RE: ***Petition No. 1352*** – Nutmeg Solar, LLC, petition for a declaratory ruling, pursuant to Connecticut General Statutes §4-176 and §16-50k, for the proposed construction, maintenance and operation of a 19.6-megawatt AC solar photovoltaic electric generating facility on approximately 162 acres comprised of 9 separate parcels located generally south of Bailey Road and east of Route 191 (Broad Brook Road), and associated electrical interconnection to Eversource Energy's Scitico Substation at 20 Bailey Road in Enfield, Connecticut

On behalf of the petitioner, Nutmeg Solar, LLC, enclosed please find an original and 15 copies of responses to the Connecticut Siting Council's interrogatories CSC-73 through CSC-94 in connection with the above-referenced proceeding.

**STATE OF CONNECTICUT
CONNECTICUT SITING COUNCIL**

Petition No. 1352

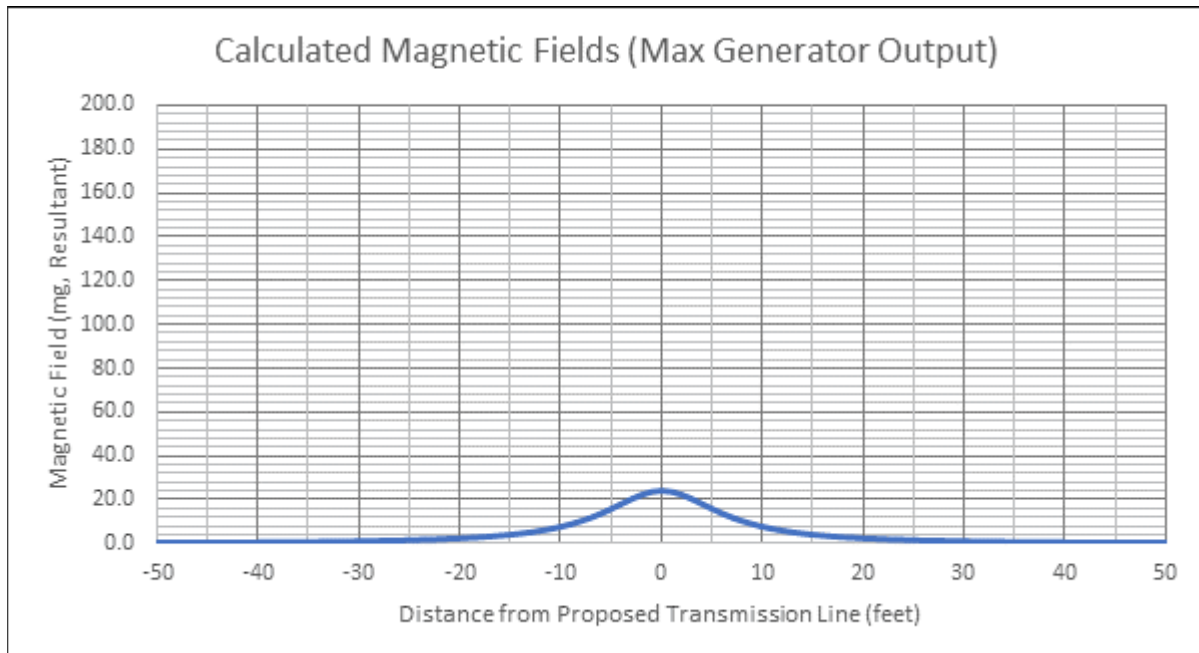
CSC-86 Provide a projected magnetic field profile in milliGauss (mG) of a cross-section of the proposed 115-kV underground line based on peak load conditions. Identify the highest projected magnetic field in that profile in mG.

The maximum anticipated field was calculated at 24.4 mG. This was assuming that the cables were carrying 100 amperes per phase, which is equivalent to 20 MVA at 115-kV. The cables were assumed to be at a depth of 42 inches below grade level for this calculation.
